ADDENDUM No. 1

PROJECT: University Medical Center Physicians DATE: 02/19/2025
New Wolfforth Clinic PROJECT NO.: 22415
Project Location

26 ROOF HATCH AND LADDER DETAIL

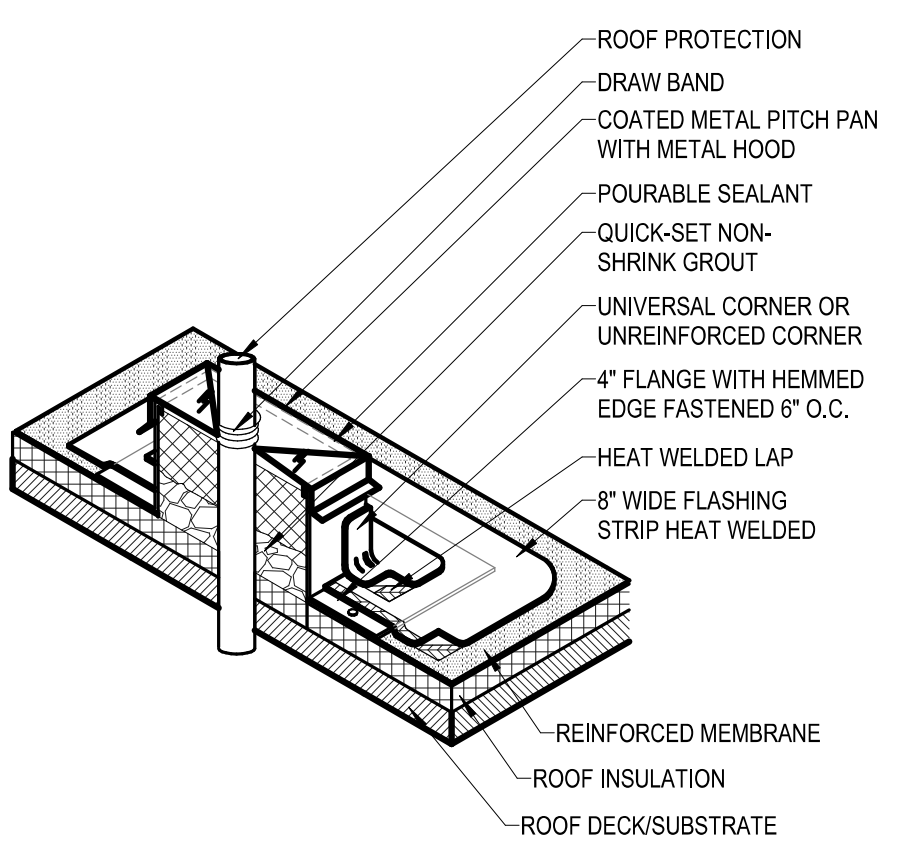
ITEM #14: Roof Ladder – Refer to attached, revised sheet A-04 for added roof over parapet ladder and graphics cleanup to show mechanical units.
